Warnell, Terry <twarnell@slo.state.nm.us> From: Sent: Wednesday, March 06, 2013 2:18 PM Dawson, Scott, EMNRD Bratcher, Mike, EMNRD FW: Cedar Lake Well Location - site review Subject: **Attachments:** Cedar Lake Well review.pdf

From: Holm, Anchor Sent: Wednesday, March 06, 2013 2:13 PM To: Warnell, Terry Subject: Cedar Lake Well Location - site review

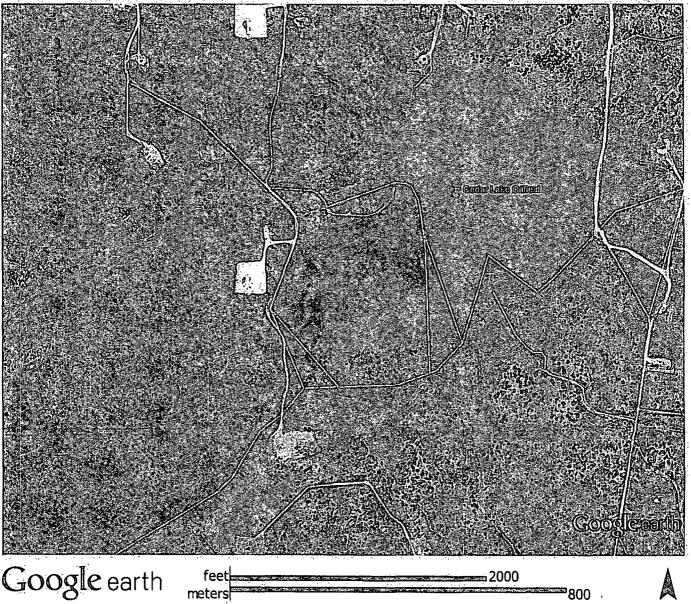
The proposed well is shown on the 3-2-2012 Google Image as having the well pad built. The well pad is well above the high water line (edge of dark grey soils) of the dry Cedar Lake, which is about 285 feet off the SE corner of the well pad. The well pad is located about 480 feet north of the floodway below Cedar Lake.

I don't see any apparent spillway issues.
